TRAILS AT OVERLAND RANCH - FILING NO. 1

FINAL DRAINAGE PLAN

TRAILS AT OVERLAND RANCH
FINAL DRAINAGE PLAN

SHEET 1 OF 11

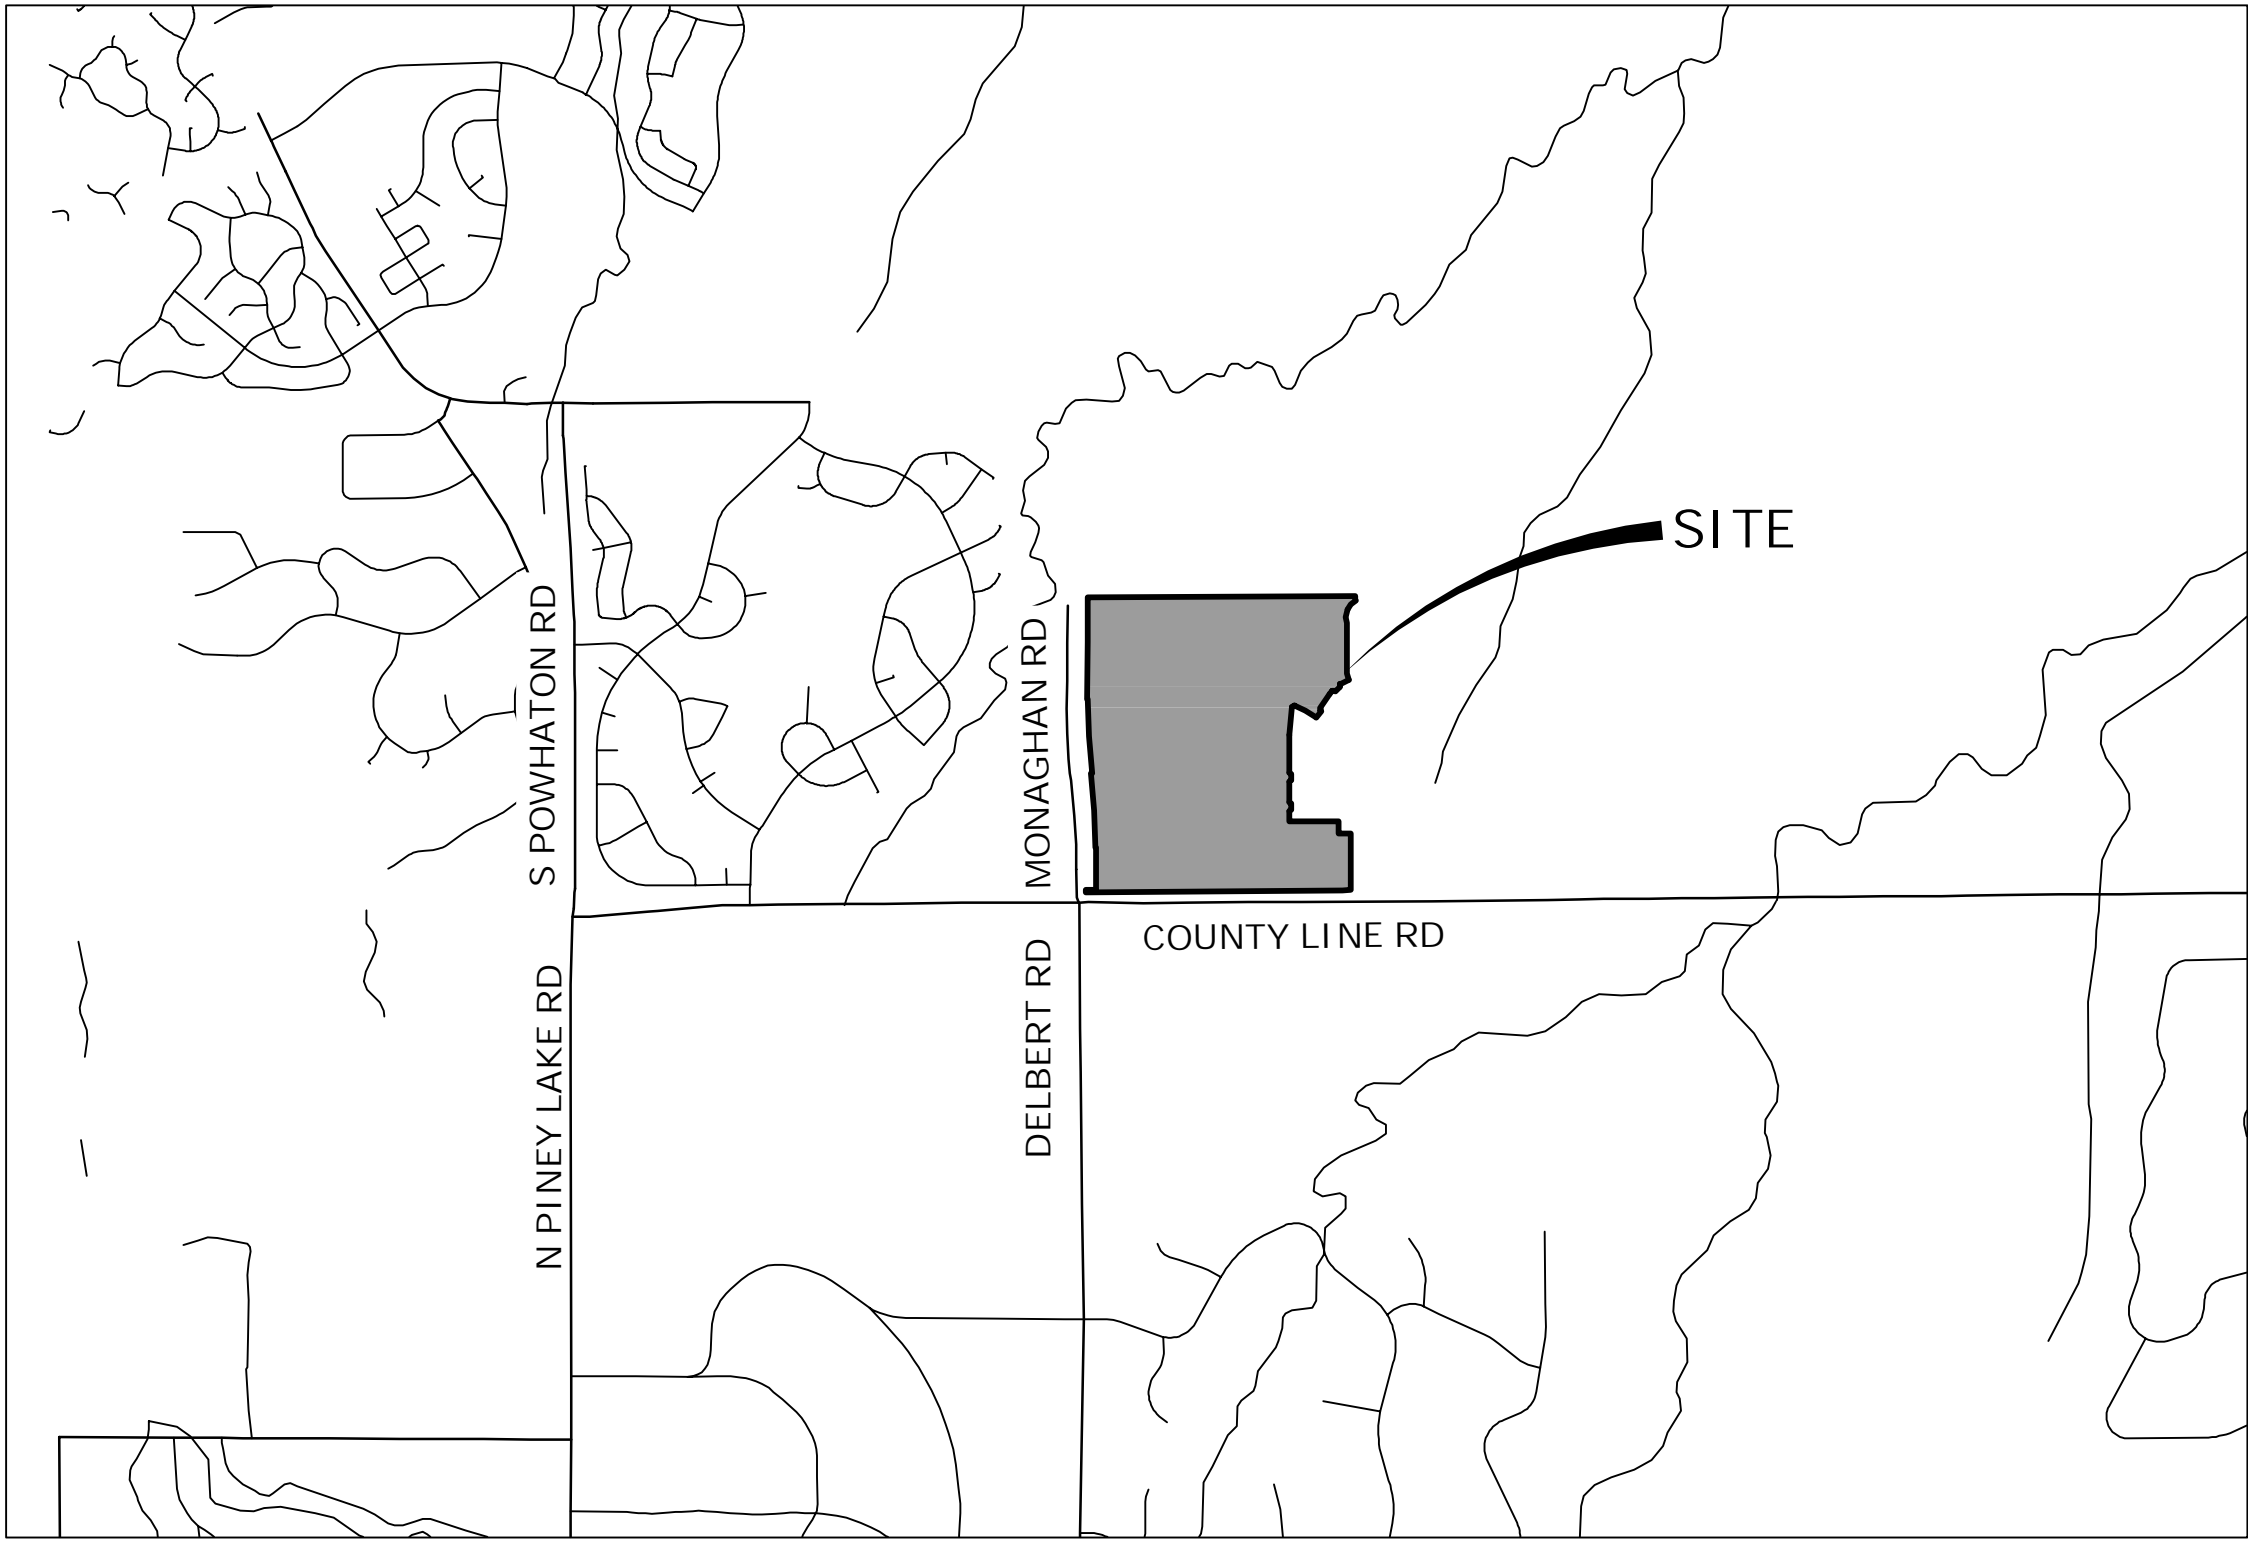
Should be Q2
JR-Column header
has been updated.

Preliminary
JR-Addressed.

Master Drainage
Plan calls for ponds
to be privately-
owned and
maintained. Other
private
infrastructure will
include swales and
area inlets. Please
revise note to
indicate privately-
owned
infrastructure are
indicated in
drainage plans

Add "Filing 01" to
title block and other
references
throughout plans

PLEASE CHANGE TO
"PRELIMINARY"
THROUGHOUT PLAN SET

JR-Notes have been revised to match the
Master Drainage Plan

JR-Addressed.

JR-Addressed.
